## AMENDMENT NO. 1 MARCH 2024

### IS 17526 : 2021 DOMESTIC STAINLESS STEEL VACUUM FLASK/BOTTLE — SPECIFICATION

**FIG. 1 DROP IMPACT TEST**

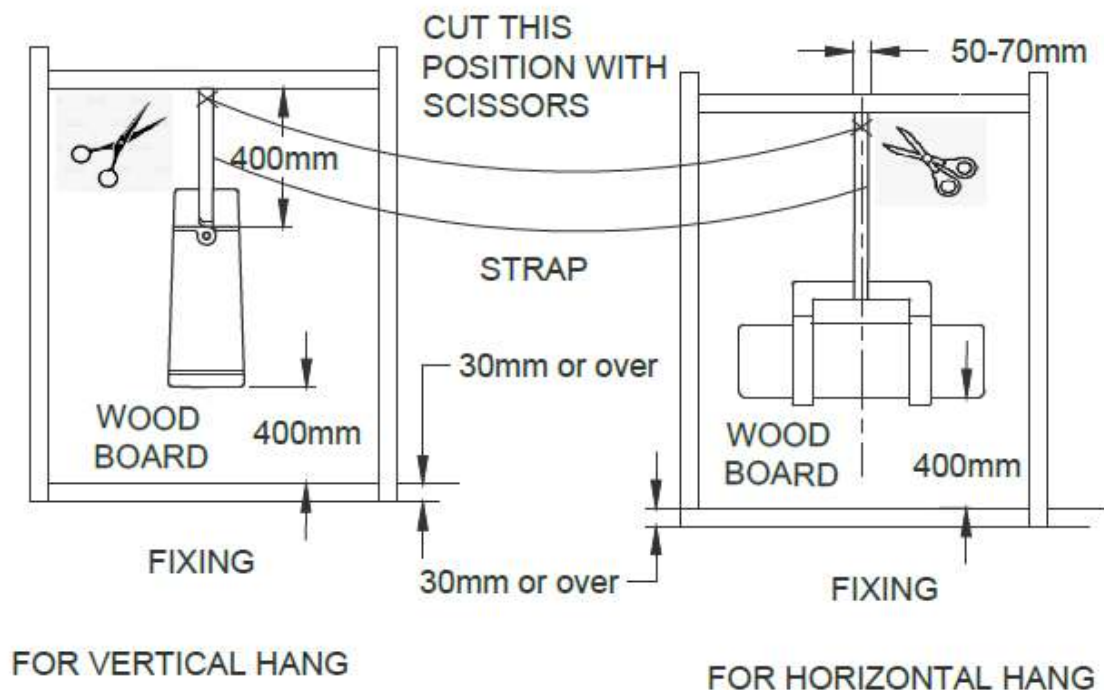
(Page 4, Fig. 1) — Substitute the following for the existing:
